**Prairie Island License Amendment Request
to Revise ISFSI TS 4.4, Codes and Standards
for the TN-40HT Casks**

06.23.2023

Figure 1 - Weld Configuration

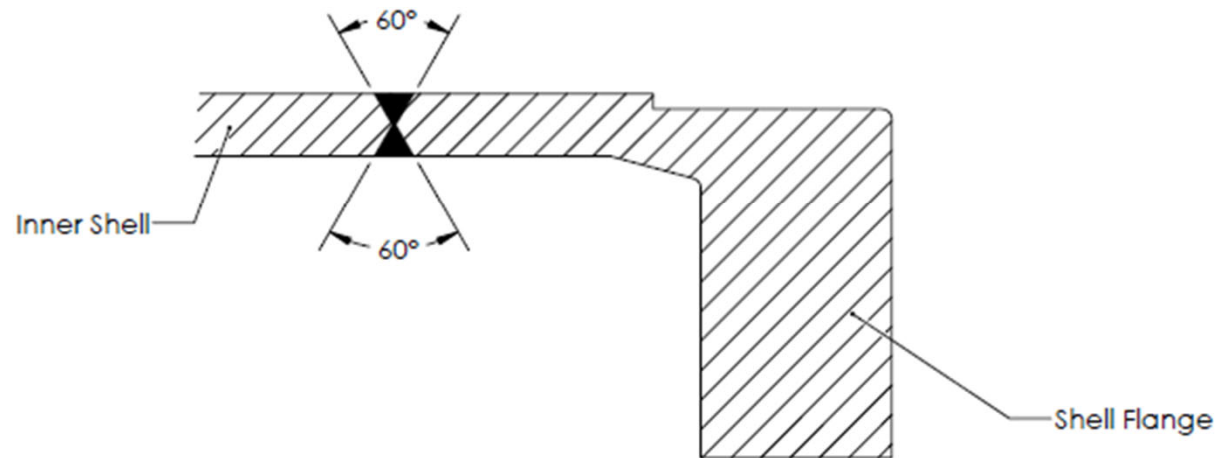
- Xcel Energy is fabricating TN-40HT casks through the OEM (Orano/TN Americas)
- The current fabrication order is for eight TN-40HT casks. Four casks have been received, three of which have been loaded.
- During fabrication of the remaining four casks, the OEM identified that a required non-destructive examination (NDE) magnetic particle (MT) inspection of the shell flange base material prior to welding (see Figure 1) was not performed in accordance with the fabrication sequence.

- Orano and Xcel Energy have developed an alternative NDE examination for the base metal and weld.
 - The alternate method uses an enhanced RT examination or a Phase Array ultrasonic (PAUT) examination along with radiography (RT) on the completed weld.
 - The examinations have been completed satisfactorily, but a License Amendment Request (LAR) is required to allow the alternate inspection method.

- Revise PINGP ISFSI TS 4.4, Table 4.4-1, TN-40HT ASME CODE EXCEPTIONS, to add optional volumetric examinations for TN-40HT inner shell welds.

<p>TN-40HT Inner Shell Welds</p>	<p>NB-5130</p>	<p>All full penetration weld edge preparation surfaces for joint Categories A, B, C, D, and similar joints in material 2 in. (50 mm) or more in thickness shall be examined by the magnetic particle or liquid penetrant method.</p>	<p>The shell flange side of the shell flange to inner shell weld if 2 in. (50 mm) or more in thickness at the time of welding may be exempt from the magnetic particle or liquid penetrant examination required by NB-5130, provided Conditions 1 and 2 below are met:</p> <ol style="list-style-type: none"> 1) The shell flange is produced from a forging. 2) The volumetric examination of the completed weld shall be modified or supplemented under option a or b below: <ol style="list-style-type: none"> a. Radiographic examination (RT): The acceptance standard for RT of the completed weld joint shall be tightened (smaller allowance of defects). The criterion for elongated indications shall be NB-5320(b)(1) instead of NB-5320(b)(2). This tighter criterion shall be applied in addition to NB-5320(a), (c), (d), and (e), without change. In addition, tighter criteria for the selection of penetrameters per NB-5111(a) shall be applied. The area of interest shall cover the weld, the weld volume and ½ in. beyond the toe of the weld on the forging side. b. Phased Array Ultrasonic examination method (PAUT): PAUT shall be performed on the completed weld joint with a defined area of examination of the weld surface and ½ in. beyond the toe of the weld on the forging side. The PAUT is in addition to completion of RT of the joint with acceptance standards of NB-5320 without modification. The acceptance standards of the PAUT shall be NB-5331(a)(1) and (b). Later editions of the ASME Section V can be used for completion of the PAUT procedure and qualification. <p>NOTE: The fabricator may elect to not implement this code alternative and perform the surface examination required by Paragraph NB-5130.</p>
